Intel[®] Xeon[®] Processor 7100 Series

Specification Update

| *March 2010*

Order Number: 314554-006

Figure 4-5. Processor Bottom-Side Markings

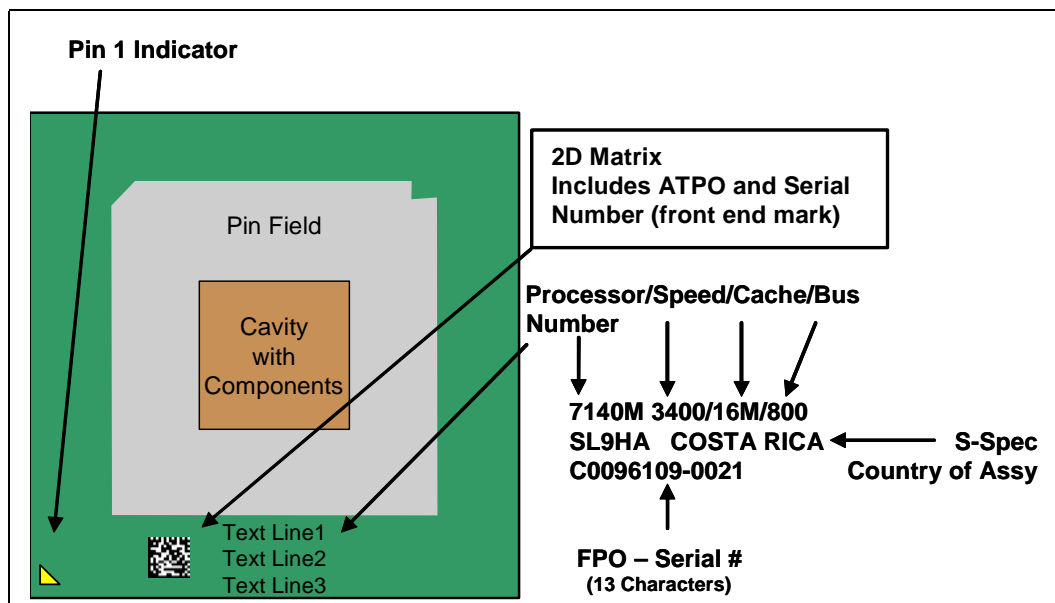
1. 2D Matrix Added to the Bottom Side Laser Mark

Figure 4-5. Processor Bottom-Side Markings has been updated to include a 2D Matrix.
